DEPARTMENT OF PLANNING AND COMMUNITY DEVELOPMENT STAFF REPORT

PLANNING COMMISSION AGENDA ITEM 5:	
Project Name:	SCE Subdivision, Lots 1 and 2 #DP-12-02
Prepared By:	Jason K. Peasley, AICP, City Planner (Ext. 229)
Through:	Tyler Gibbs, AIA, Director of Planning and Community Development (Ext. 244)
Planning Commission (PC):	August 23, 2012
City Council (CC):	September 4, 2012
Zoning:	Gondola – One (G-1) and Resort Residential - One (RR-1)
Applicant:	Ski Country, LLC c/o Eric Smith Associates P.C., 1919 7 th Street, Boulder, CO 80203, (303) 442-5458
Request:	Conceptual Development Plan for a 74 unit condominium project located at the corner of Burgess Creek Road and Storm Meadows Drive. This application contains a front setback variance for retaining walls over four feet in height and a variance to allow a 6 foot sidewalk along the property frontage.

Sheet Title
 SITE PLAN WITH BUILDING
 HEIGHT ENVELOPE

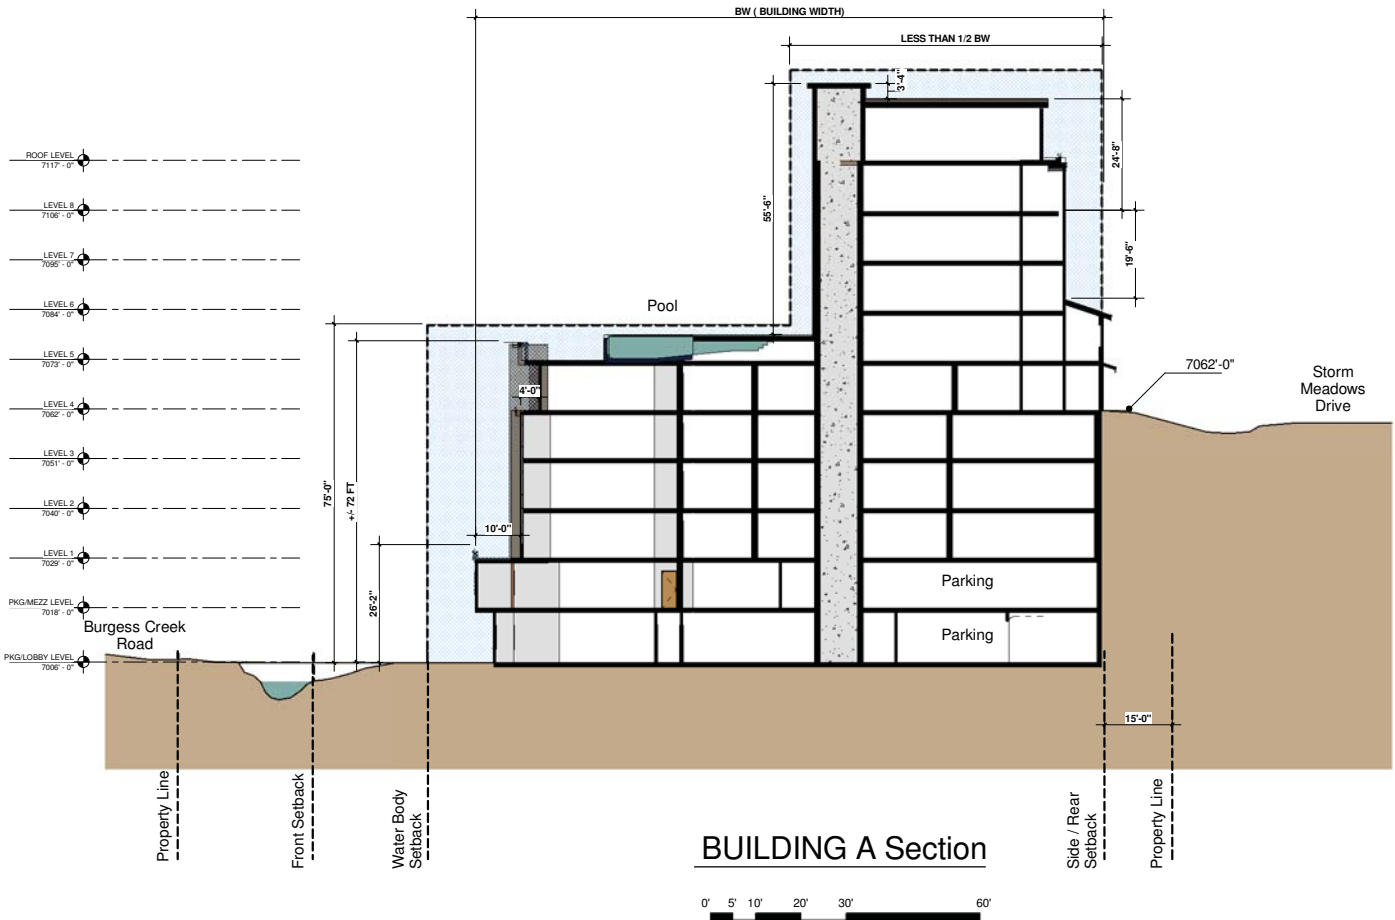
STANDARD	RR-1	G-1	PROPOSED	COMPLIES?
Lot Area	6,000 sf. Min.	6,000 sf. Min.	91,911 sq. ft. (2.11 acres)	Yes
Lot Coverage	0.50 Max.	0.60 Max.	0.42	Yes
Building Height	63 feet overall height Max.	75 feet overall height Max.	South Tower: 75 feet OH Middle Tower: 63 feet OH North Tower: 63 feet OH	Yes
Front Setback (Burgess Creek Road)	20 ft (1 st and 2 nd Story) Min. 25 ft (3 rd Story) Min.	Per Mountain Town Sub-Area Plan	35 ft (1 st and 2 nd Story) 50 ft (3 rd Story) 1 ft. (retaining walls)	VARIANCE REQUIRED
Front Setback (Strom Meadows Drive)	20 ft (1 st and 2 nd Story) Min. 25 ft (3 rd Story) Min.	Per Mountain Town Sub-Area Plan	20 ft (1 st and 2 nd Story) 25 ft (3 rd Story)	Yes
Side/Rear Setback	15 feet Min.	Per Mountain Town Sub-Area Plan	15 feet	Yes
Waterbody Setback	12 feet- while this is the minimum setback, the intent is to have areas in excess of twelve (12) feet in order to provide for greater area for landscaping.		15-40 feet (main building)	Yes

Sheet Title
 COMPREHENSIVE SHADOW PLAN

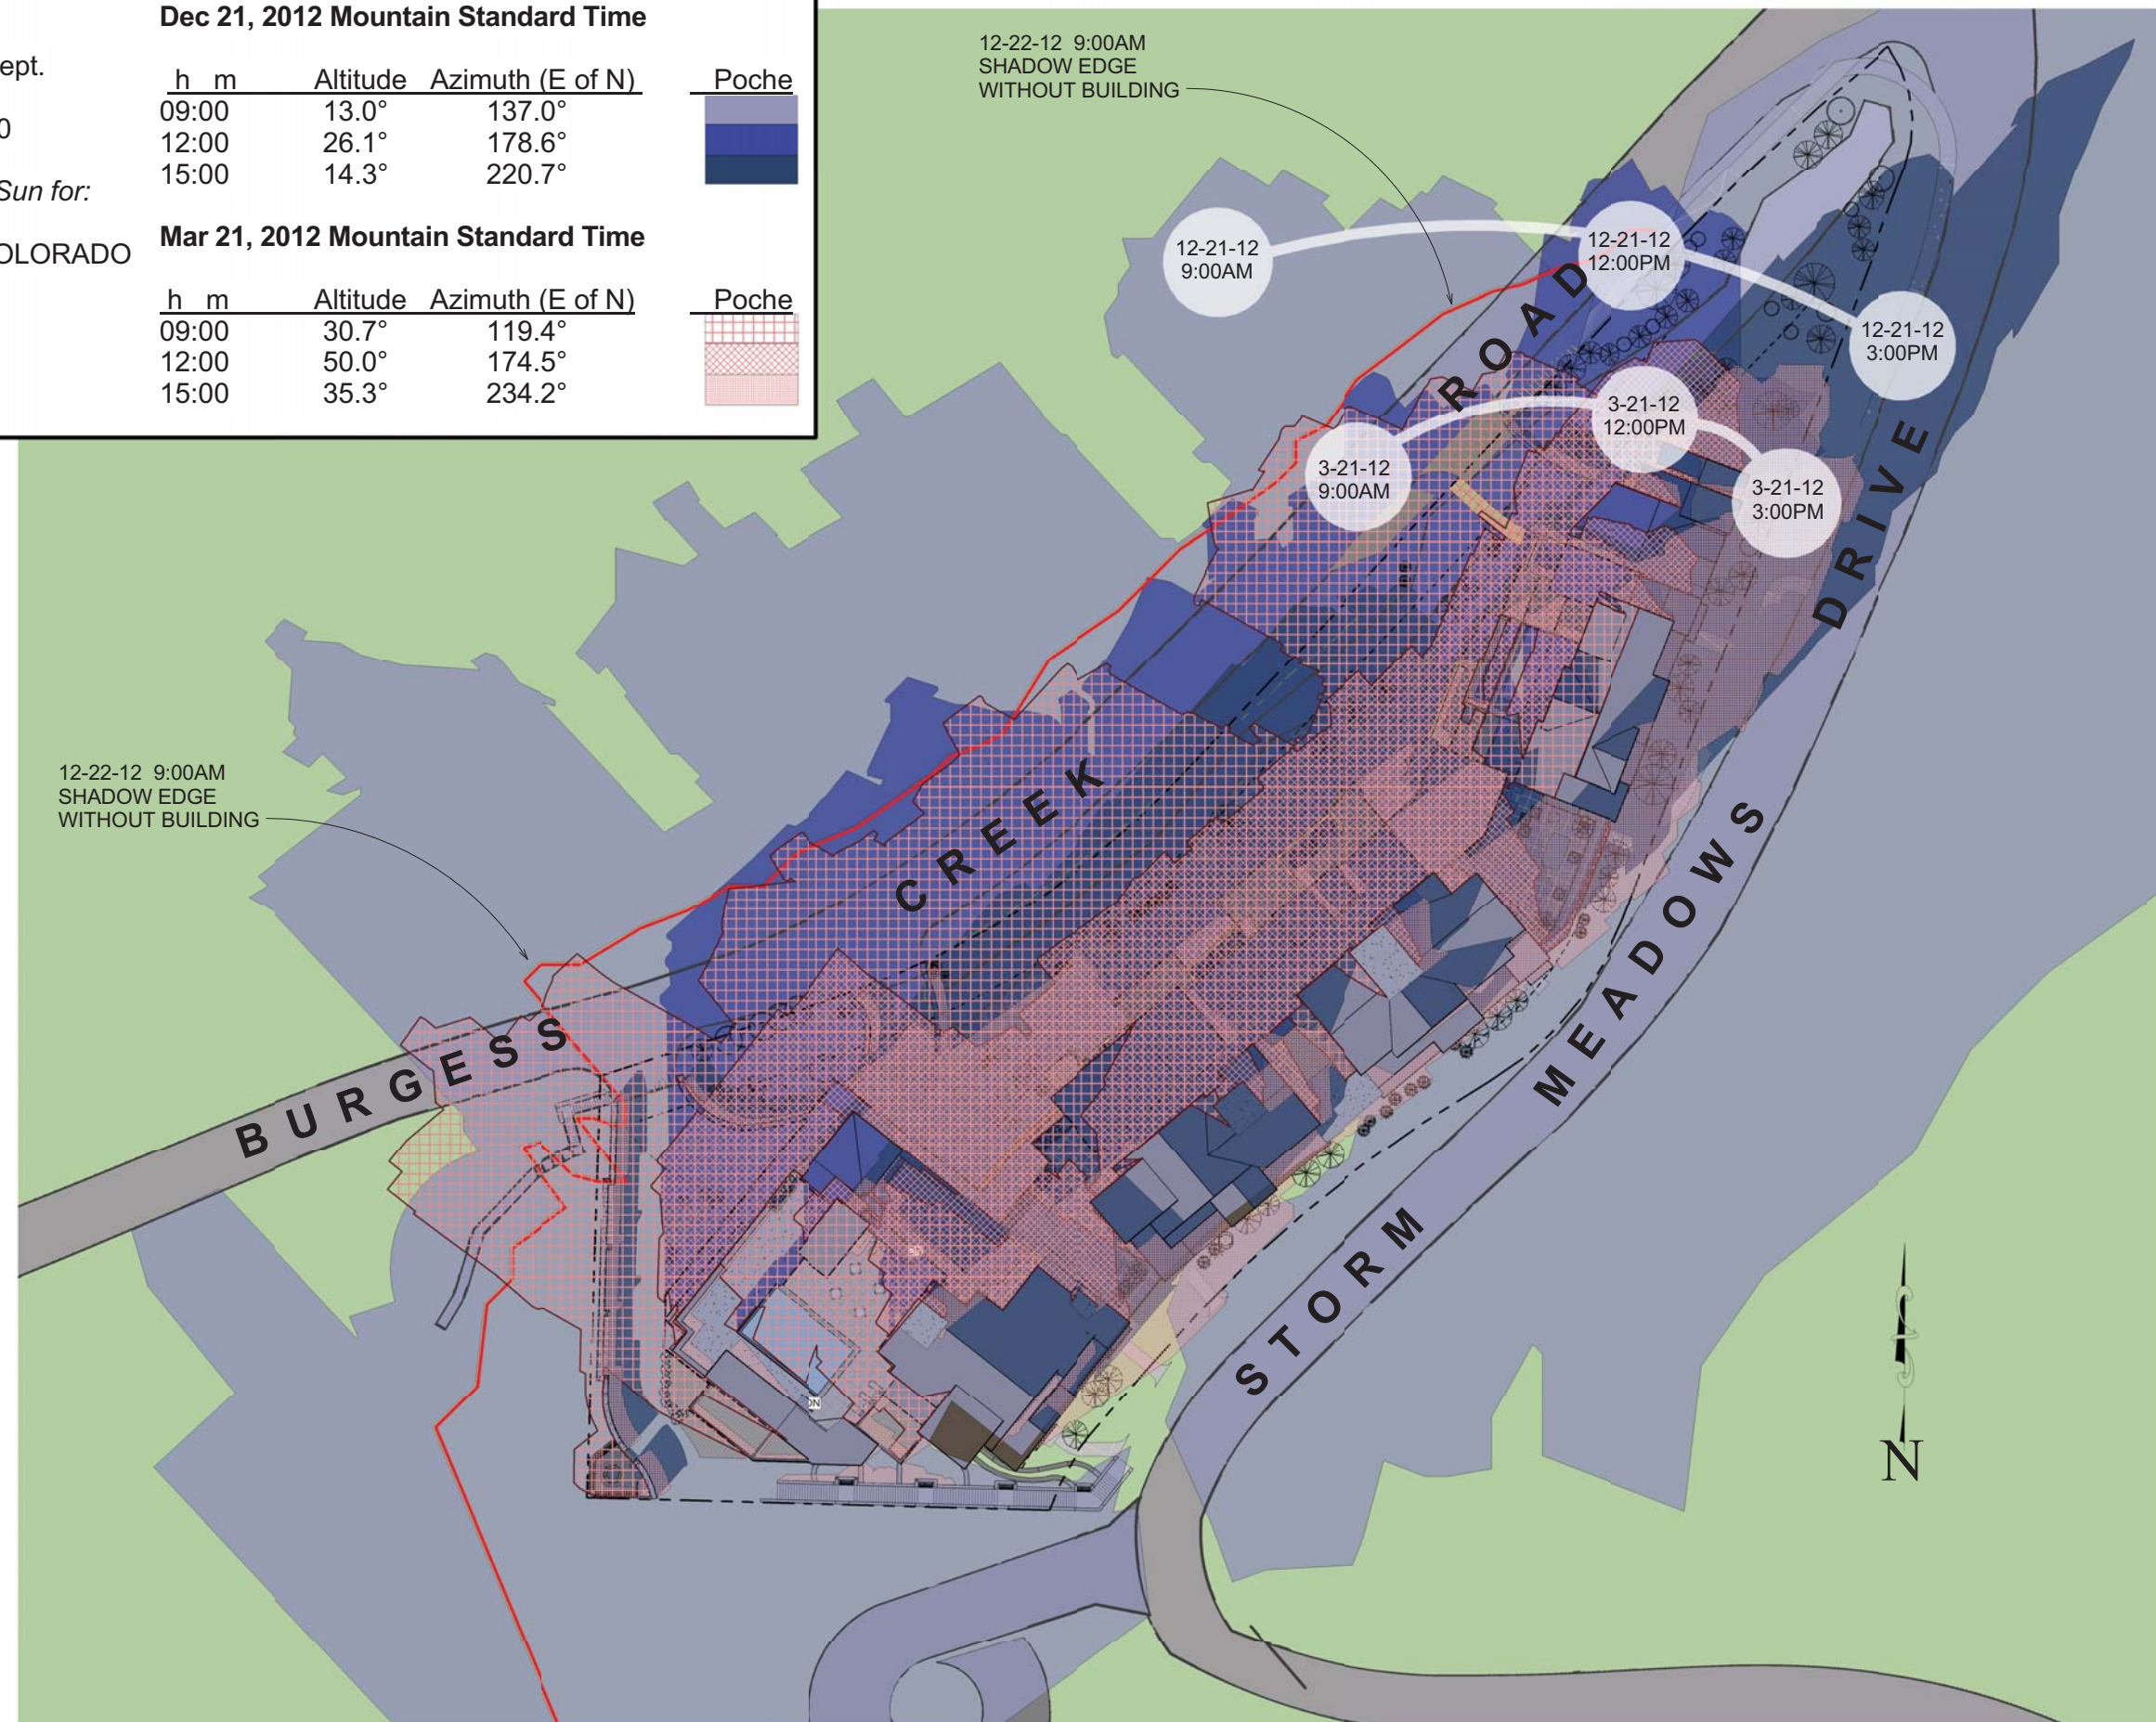
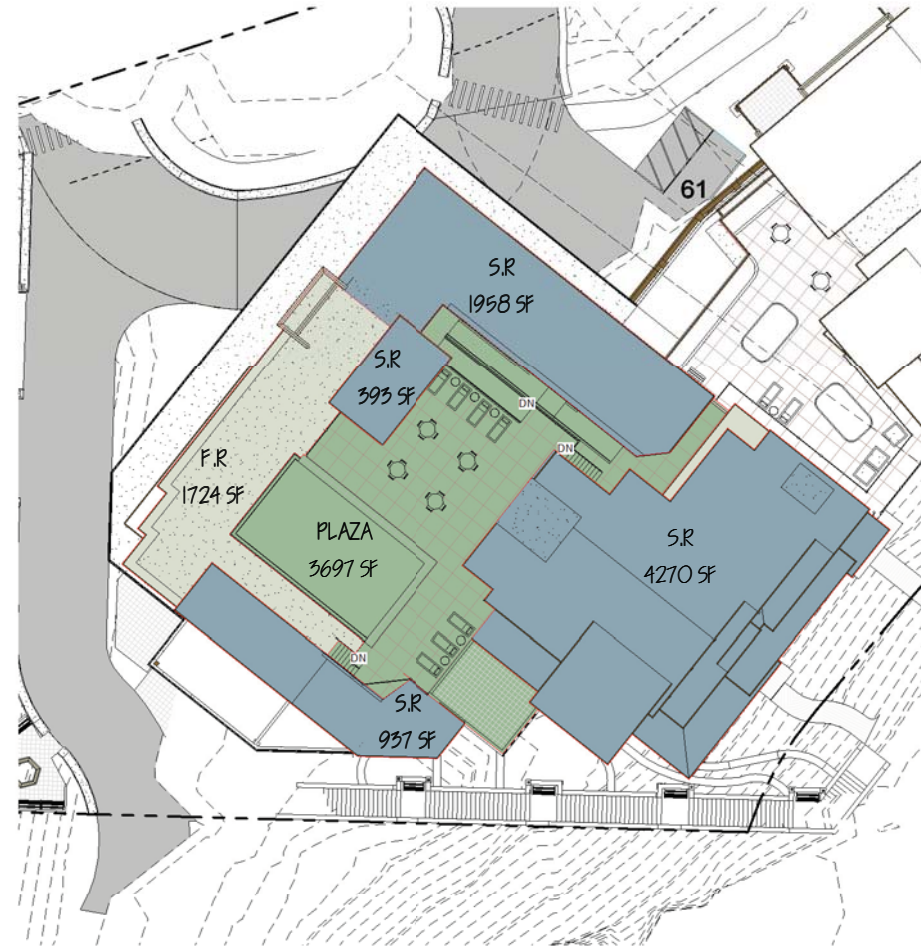
Staff Comments: **Consistent;** The proposed site is located in a narrow section of the Burgess Creek drainage and experiences a great deal of shadowing from nearby ridges in the winter months. The addition of the proposed building will result in shadowing of their planned pedestrian walkway along Burgess Creek. All of these spaces, including driveways will be snow melted to mitigate the impacts of increased shadowing. The pedestrian area to the south of the project along the emergency access to Bronze Tree will receive the most substantial sun exposure of any of the planned public space. The shadow effects on Burgess Creek Road and Storm Meadows Drive will result in more demand for snow removal and may create a more challenging driving environment when not properly maintained.
